**CHANGE
REQUEST
NO. ILC-CR-NNNN**

[ORIENTATION OF ELECTRON/POSITRON LINACS]

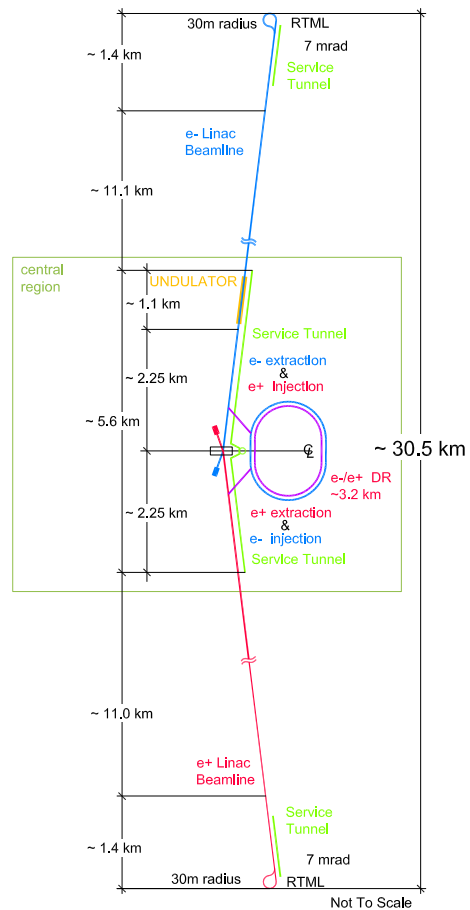
The orientation of the accelerator complex in TDR is shown in Figure 1. The electron linac drawn on the upper side and the positron linac on the underside with the damping ring on the right side. The present change request is to flip the two main linac, i.e, the electron- and positron-linacs is on the upper side and on the underside, respectively, with the damping ring on the right side.

The proposed site in Kitakami area is a granite area which is long in the north-south direction, therefore the main linac is to be constructed in the north-south direction. Since the elevation tends to be lower in the west side, all the portals of the access tunnels, as well as the damping ring, should be on the west side of the main linacs to minimize the total length of the access tunnels. Since the elevation tends to be higher in the north compared to the south, and the arrangement of the utility caverns is not symmetrical with respect to the interaction point, the total length of access tunnels can be minimized by flipping the electron- and positron linacs. The current siting study suggests the total length of access tunnels would be minimized if the electron linac is on the north side and positron on the south side.
